SYDNEY WEST CENTRAL PLANNING PANEL

COUNCIL ASSESSMENT REPORT

Panel Reference	2017SWC020 DA
DA Number	DA/80/2017
LGA	City of Parramatta
Proposed Development	Construction of temporary 1 - 2 storey demountable school buildings for 1,000 students on the existing school oval, including associated access works, tree removal and signage. Demolition of temporary school buildings and return to use as oval after 1 year of operation. This application is Nominated Integrated Development under s58 of the Heritage Act 1977. This application is Crown development under s89 of the Environmental Planning and Assessment Act 1979.
Street Address	24 O'Connell Street & 3 Marist Place PARRAMATTA NSW 2150 (Lot 6 DP 1182647 & Lot 1 DP1112822)
Applicant/Owner	NSW Department of Education (Crown Development)
Date of DA lodgement	2 February 2017
Submissions	None
Recommendation	Refusal (requires concurrence from NSW Minister for Planning)
Regional Development Criteria (Schedule 4A of the EP&A Act)	Pursuant to Clause 5 of Schedule 4A of the Environmental Planning and Assessment Act 1979, the application is Crown development with a capital investment value of more than \$5 million.

Report date	3 April 2017

Figure 6. Flood Affection Map 1 overlaid on proposed floor plan.

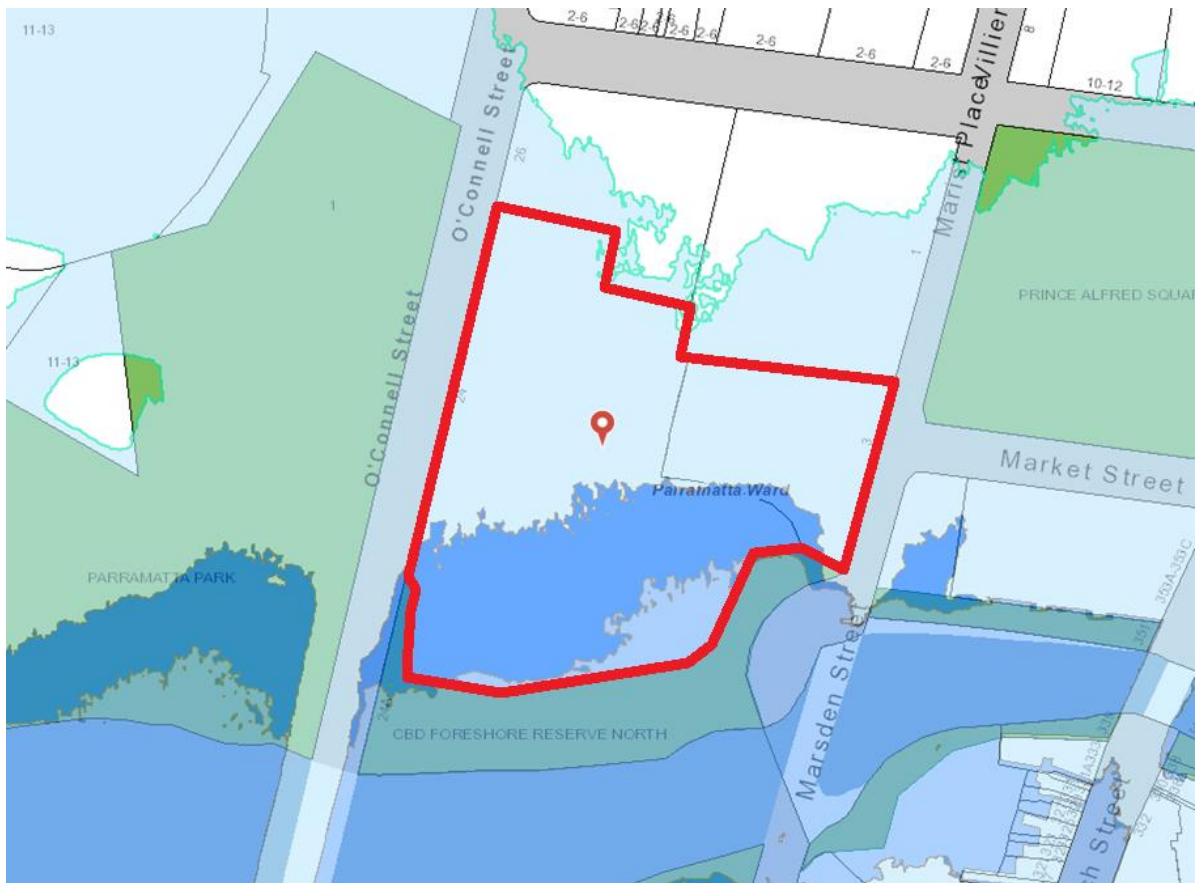
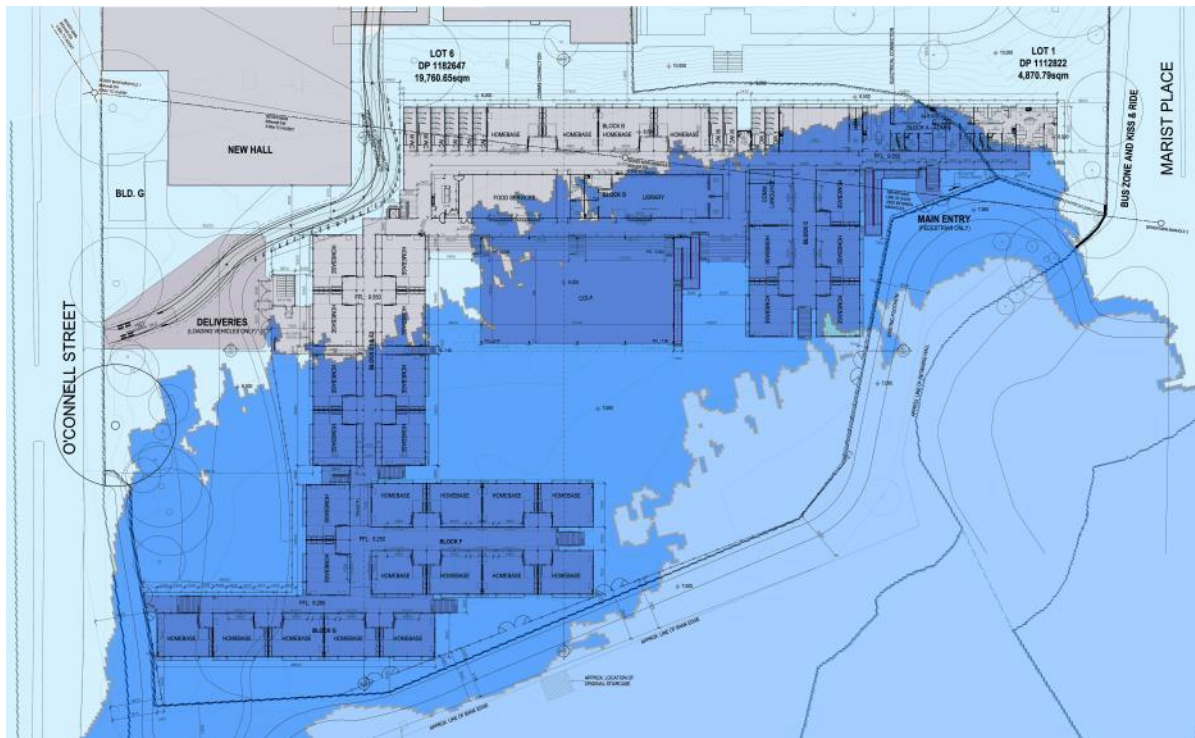
The site is subject to a 1:20 year, 1:100 year, Probable Maximum Flood and Low to High Flood Hazard. 'Flood Hazard' is defined as the potential to cause damage to the community. The extent of each affectation is outlined in Figures 5 – 8 below.

The proposed school footings would be almost entirely inundated by the 1% Annual Exceedance Probability (100 Year) flood - to approx. 8m AHD (up to 1m above ground level). The proposed ground floor level is 9.25m - 9.55m AHD and as such would meet the minimum freeboard requirements for the 1:100 year flood. The covered outdoor learning area (COLA) would be at 8m AHD and as such would not meet the freeboard.

The Probable Maximum Flood (PMF) is approx. 13m AHD (4m to 5m above ground level). The proposed first floor level is 12.9m AHD and as such would not provide refuge in place for the PMF.

Figure 8. Flood Affection Map 2 overlaid on proposed floor plan.

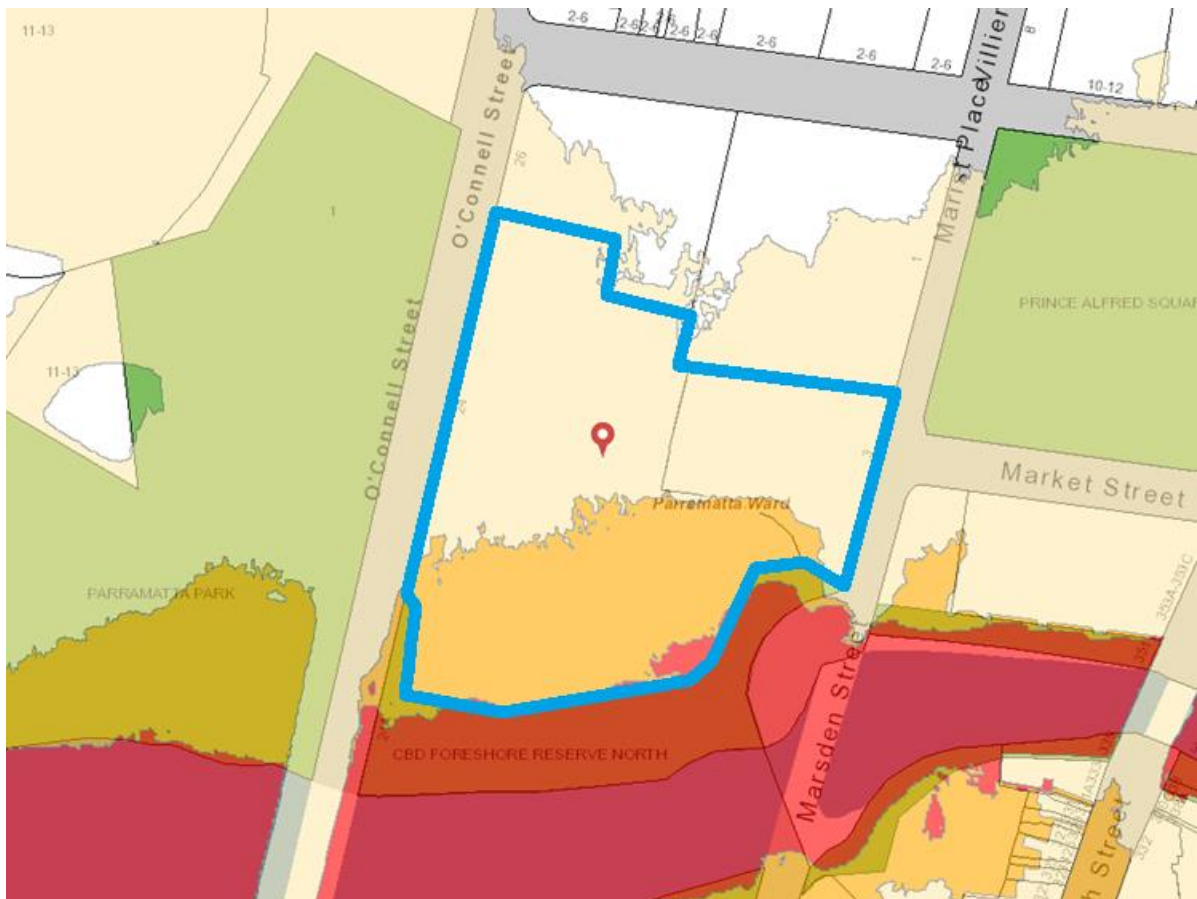
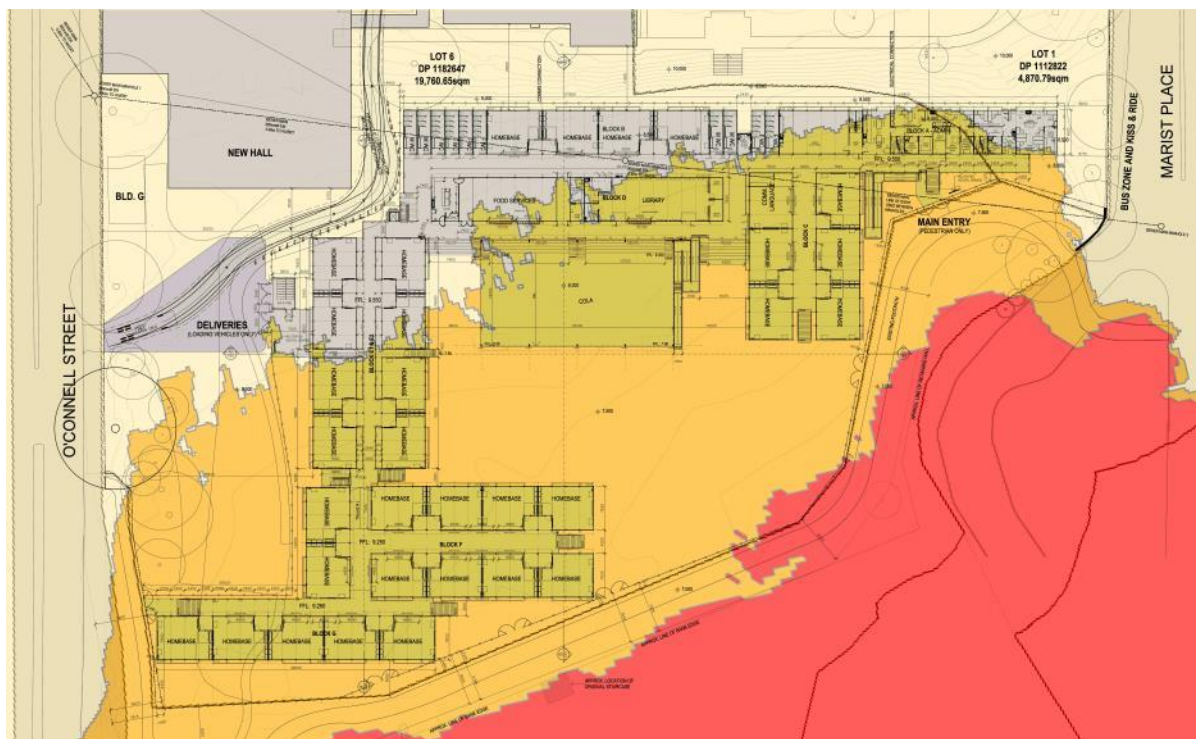
1:20	1:100	PMF	Max Hazard
<i>Access to Temporary School Site</i>	No	Yes	Yes	Medium
<i>Temporary School Buildings</i>	Minor	Yes	Yes	Medium
<i>Temporary School Grounds (accessible to children during play)</i>	Yes	Yes	Yes	High
<i>Temporary School Fence</i>	Yes	Yes	Yes	High
